Updated Final Environmental Impact Report

Old Arcata Road Rehabilitation & Pedestrian/Bikeway Improvements

City of Arcata

January 31, 2022

FIGURE 16
PROPOSED ROUNDABOUT AT
HISTORIC BAYSIDE CORNERS

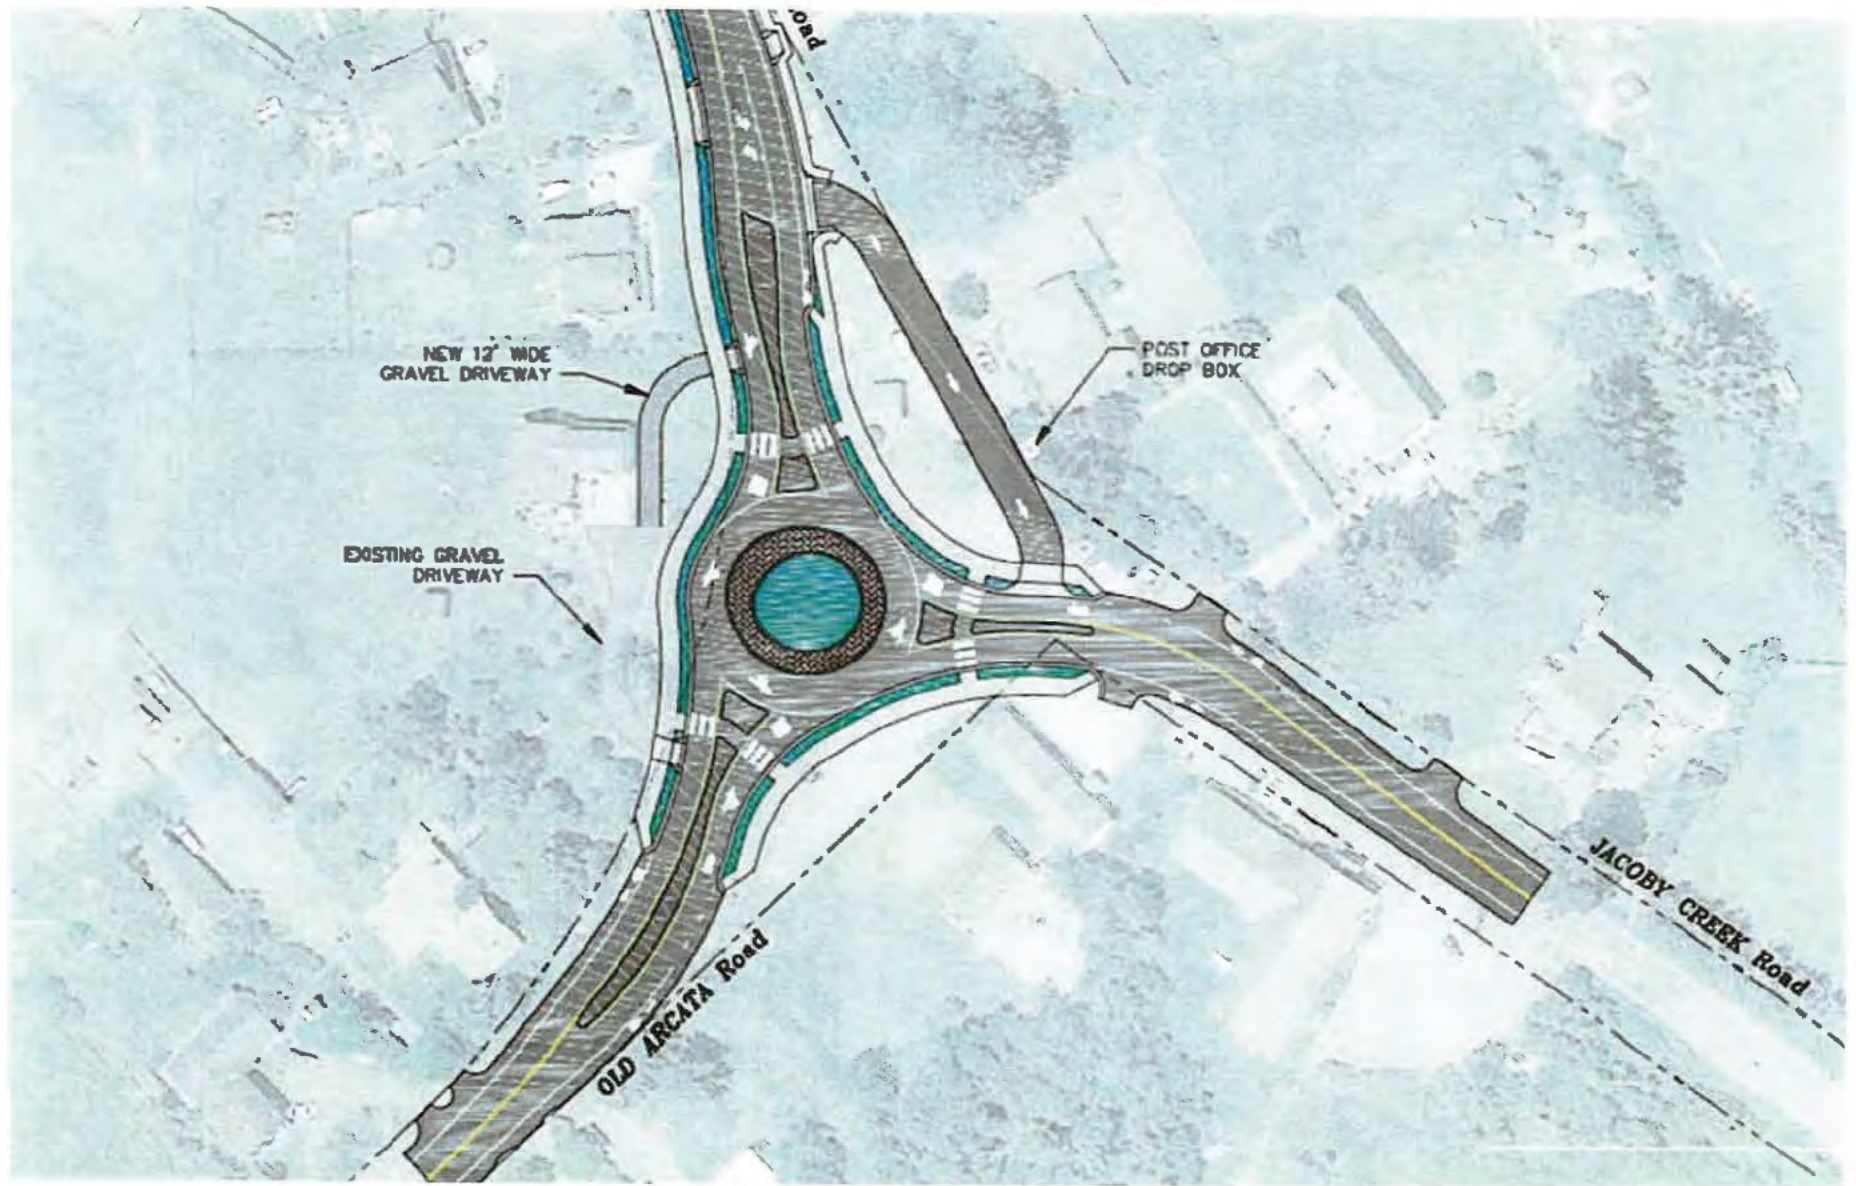
cumulative effect that is irreversible. Once the "Corners" is gone and replaced by a Roundabout the area will no longer reflect the historical development of the town and the old road that connected people to the historic nucleus of Bayside and the heart of the community. (See Figure 16)

Image 1. Excerpt of the 30% design planset (sheet 16, roundabout) showing the enhanced crosswalk sign and detectable warning surfaces, shown in yellow.

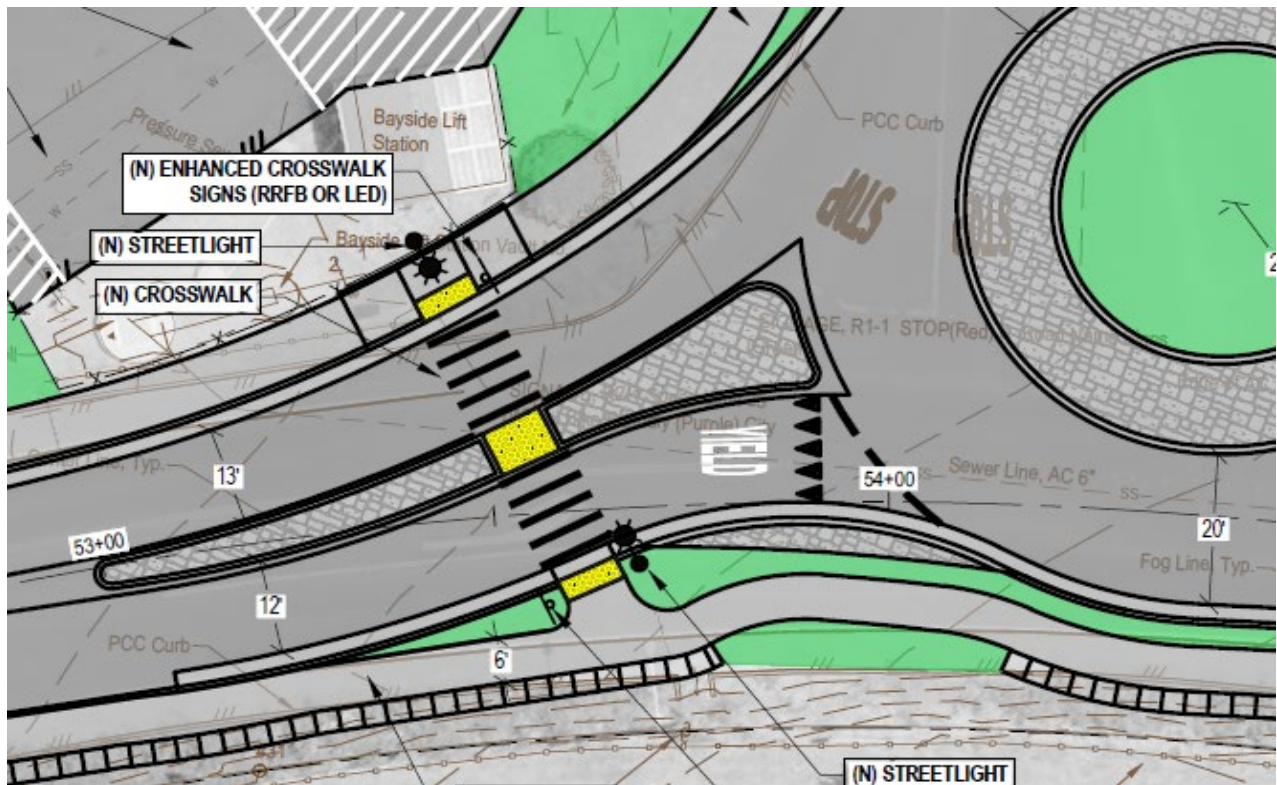
7. **Failure to describe protection measures to protect sight and hearing impaired children at crosswalks near the roundabout** – The comment regards safety measures for sight and hearing impaired individuals using crosswalks near the roundabout. Under existing conditions, there are not any crosswalks at the intersection of Old Arcata Road and Jacoby Creek Road, and community members are forced to cross the roadway absent any pedestrian facilities for anyone, including the hearing and sight impaired. The Project proposed to integrate two new crosswalks into the intersection to facilitate pedestrian safety and improve the overall walkability of the community. The Project would be designed consistent with applicable design safety guidelines as detailed on page 2-3 and 2-4 of the DEIR in Section 2 (Project Description), which include Americans with Disabilities Act (ADA) guidelines, including required provisions for sight and hearing impaired children at crosswalks. Within the circulatory portion of the roundabout, a landscape buffer will be provided to help direct users who are visually impaired to the crosswalks. As indicated in Section 2.4.5 of the Project Description (page 2-4), all crosswalks across Old Arcata Road and Jacoby Creek Road are proposed to include user activated warning lights (e.g., LED enhanced signs or rectangular rapid-flashing beacons [RRFB]). The push buttons for the warning lights will be ADA compliant and will include visual and audible activation confirmation. The curb ramps at the crosswalks would also include detectable warning surfaces (Image 1). Detectable warnings are a distinctive surface pattern of domes detectable by cane or underfoot that alert people with vision impairments of their approach to street crossings and hazardous drop-offs. The full 30% design set has been added as Appendix C of the FEIR and show the locations of the detectable warning surfaces. The 30% design set also remains available on the City's Project-dedicate website, where it was posted during circulation of the DEIR, <https://www.cityofarcata.org/720/Old-Arcata-Road-Design-Project>. The comment does not present a new environmental impact or concerns that were not fully addressed in the DEIR. No amendments, additional clarifications, or additional mitigations are warranted to address environmental impacts.

Client	CITY OF ARCATA		
Project	OLD ARCATA ROAD IMPROVEMENTS		
Title	OLD ARCATA RD - STA 6+00 TO STA 11+00		
Project No.	11159130		
Original Size	ANSI D	Sheet No.	C-102

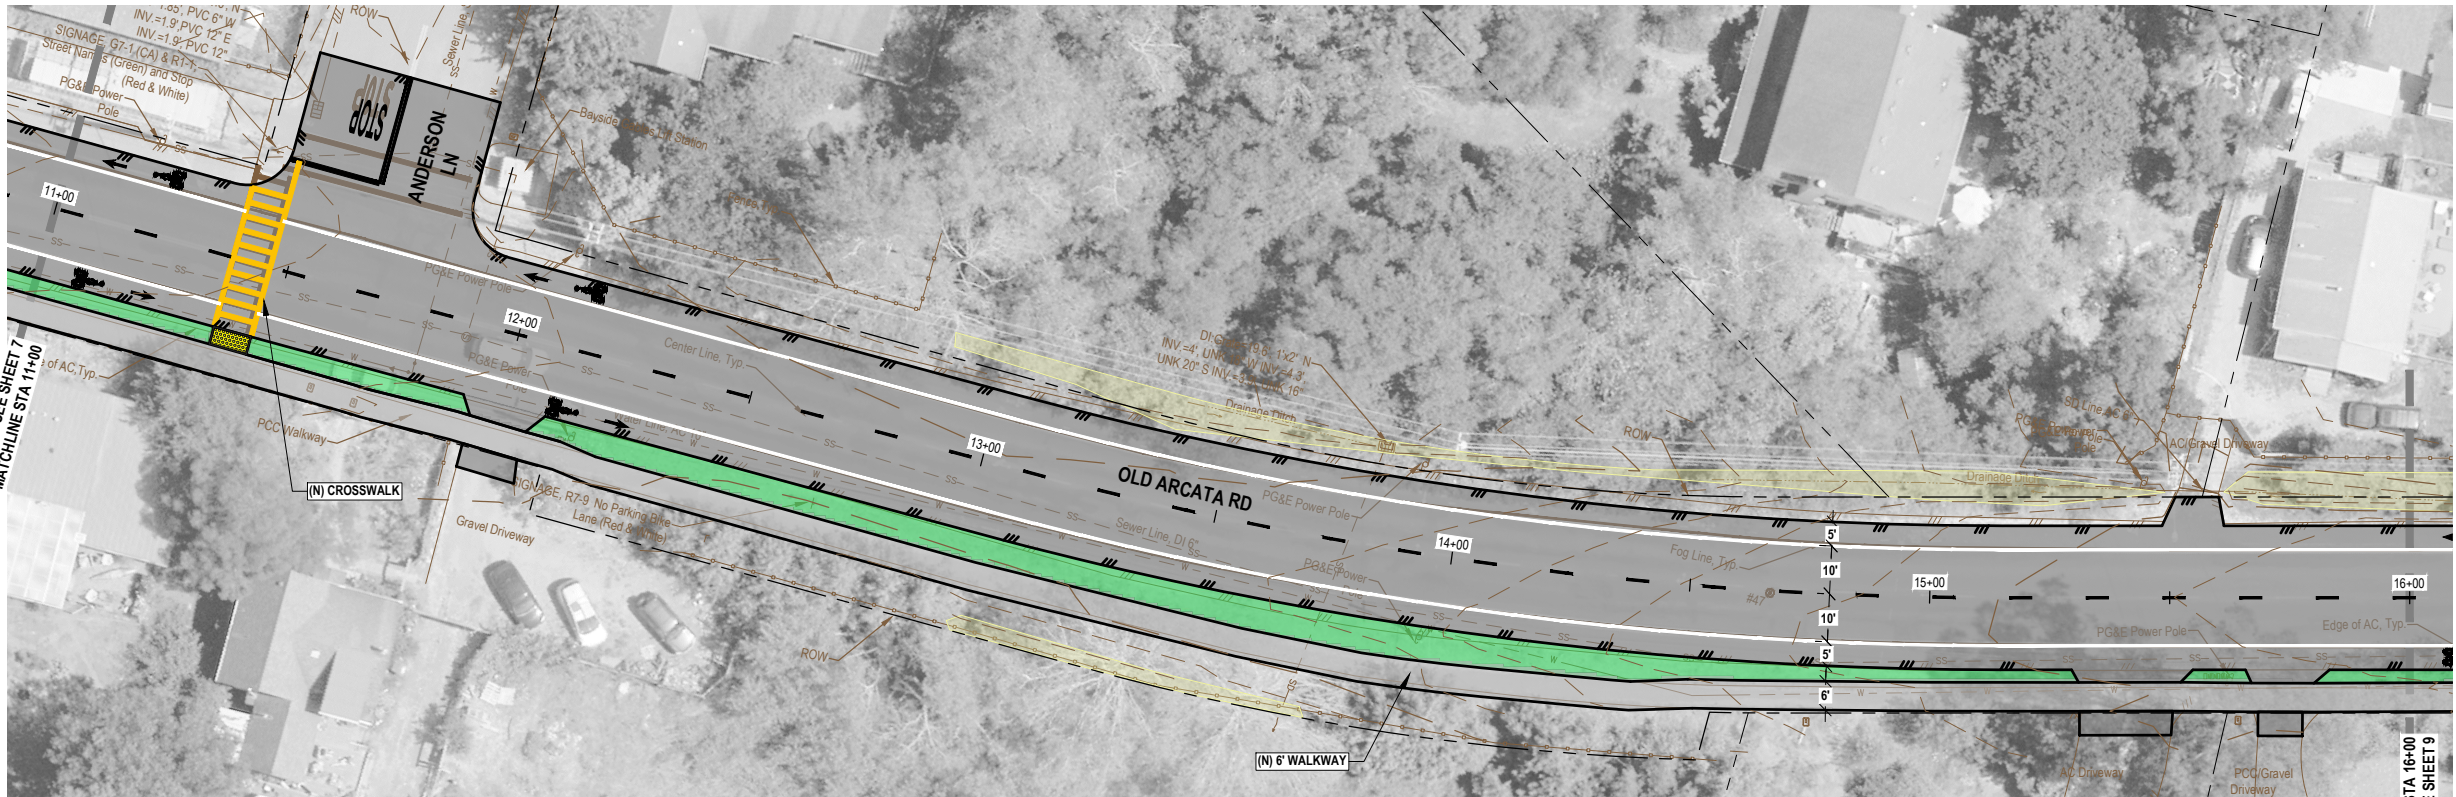
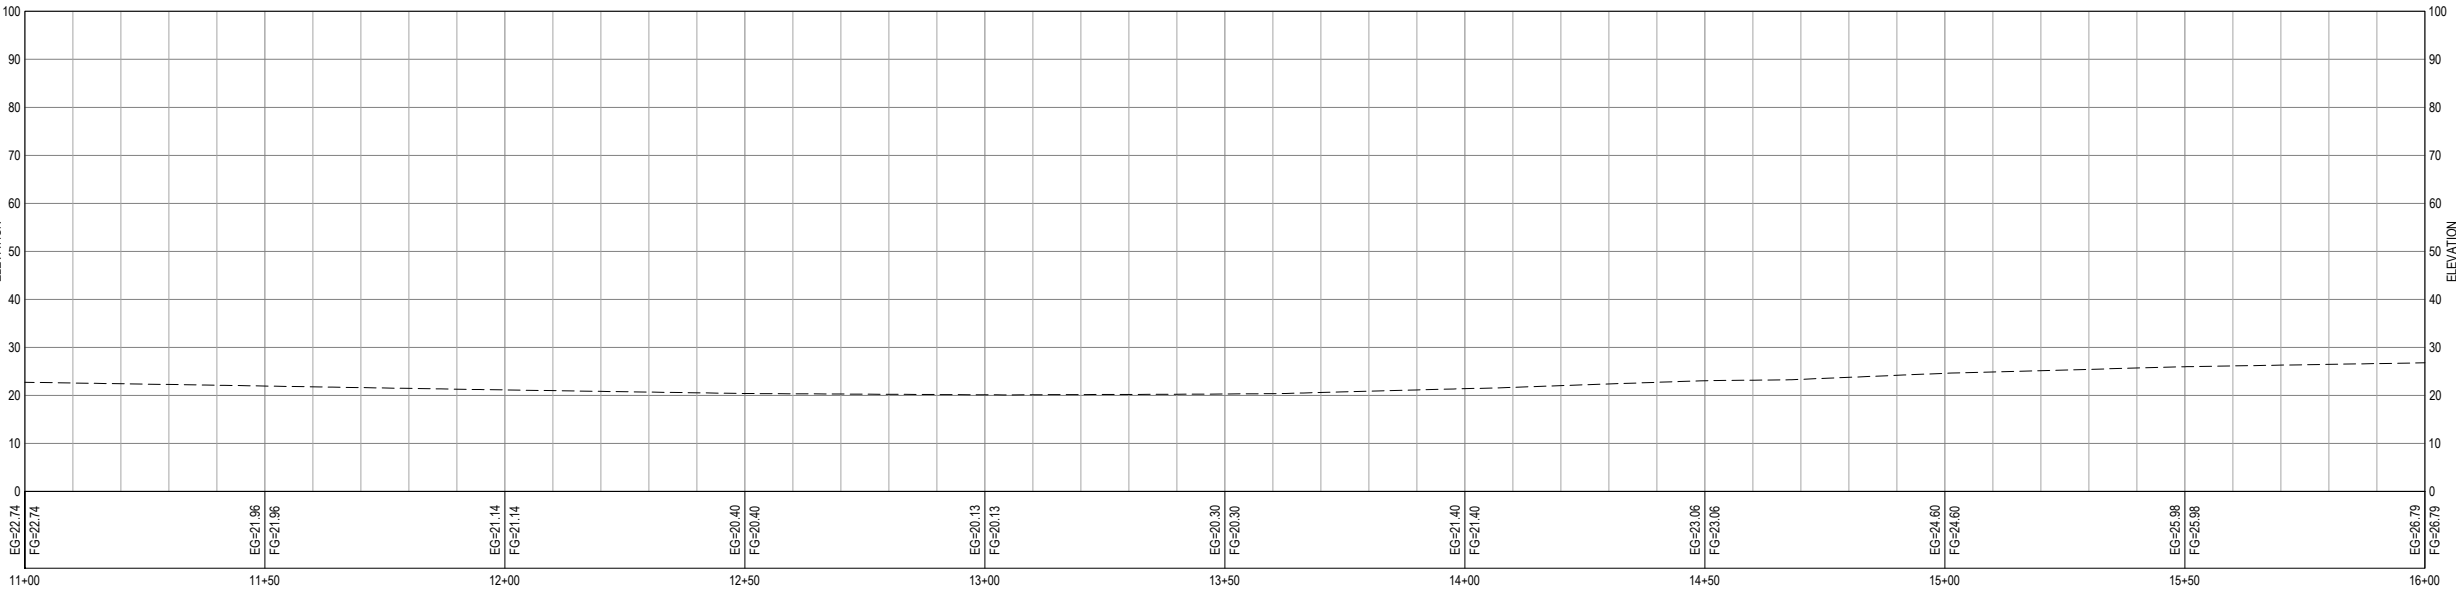
The Partially Recirculated Draft EIR noted permanent impacts to approximately 20 square feet of three-parameter coastal wetland along Bayside Road near the northern end of the Project alignment (see Figure 3.3.-2 Wetlands Near Bayside Road). The sidewalk in this location has since been adjusted to avoid the approximately 20 square foot impact, shown on Sheet C102 of Appendix B.
